Access Compliance Report

Public Rights-of-Way

(Curb Ramps)

Intersection ID: N/A	Main Street: NATIONS_FORD_RD	Cross Street: N/A	Location: E
ADA ID: 5C5D96FC9E7C	Ramp Type: Para	Initial Pass/Fail: Pass	Overall Compliance: No
Codes/Mitigation Info/Possible Solution		Field Measurements/Component Compliance	
Severity Score: 0.25

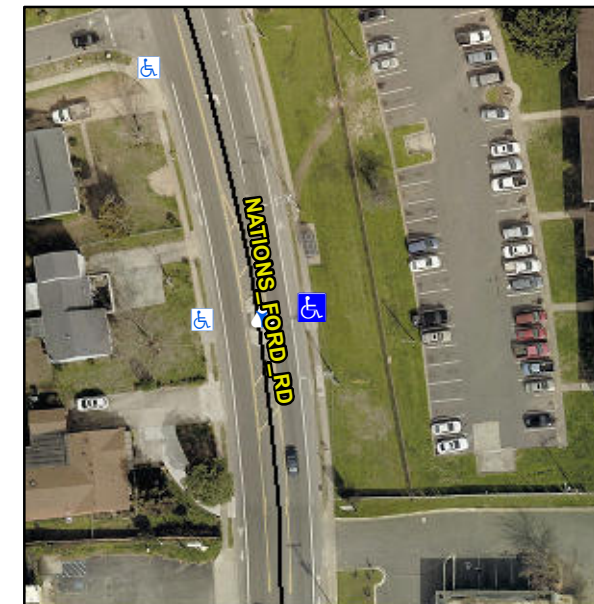
**Remove & Replace Entire Ramp.
Gutter Ponding Observed.**

R304.5.3, R302.7

Compliance	Description	Data	Compliance	Description	Data
N/A	Ramp Length LT (in)	75.0	N/A	Ramp Length RT (in)	74.0
Yes	Ramp Width LT (in)	64.5	Yes	Ramp Width RT (in)	63.0
Yes	Ramp Slope LT (%)	7.0	Yes	Ramp Slope RT (%)	7.7
Yes	Ramp XSlope LT (%)	1.6	No	Ramp XSlope RT (%)	3.6
Yes	Landing Length (in)	63.0	Yes	DWS Provided?	Yes
Yes	Landing Width (in)	60.0	Yes	DWS Contrast?	Yes
Yes	Landing Slope (%)	0.4	Yes	DWS Length (in)	24.0
Yes	Landing X Slope (%)	0.0	Yes	DWS Full Width?	Yes
N/A	Landing Curb? (Y/N)	Yes	Yes	DWS Offset (in)	1.0
N/A	Shared Landing?	No			
No	Gutter Ponding?	Yes	Yes	Gutter Slope (%)	0.7
Yes	Gutter Lip Ht (in)	0.0	Yes	Gutter X Slope (%)	0.5
N/A	Painted X Walk1?	No	N/A	Painted X Walk2?	N/A
	X Walk 1 Direction	To W		X Walk 2 Direction	N/A
N/A	X Walk 1 Width (in)	N/A	N/A	X Walk 2 Width (in)	N/A
	X Walk 1 Slope (%)	4.7		X Walk 2 Slope (%)	N/A
	X Walk 1 X Slope (%)	0.8		X Walk 2 X Slope (%)	N/A
N/A	Ramp inside XWalk1?	N/A	N/A	Ramp inside XWalk2?	N/A
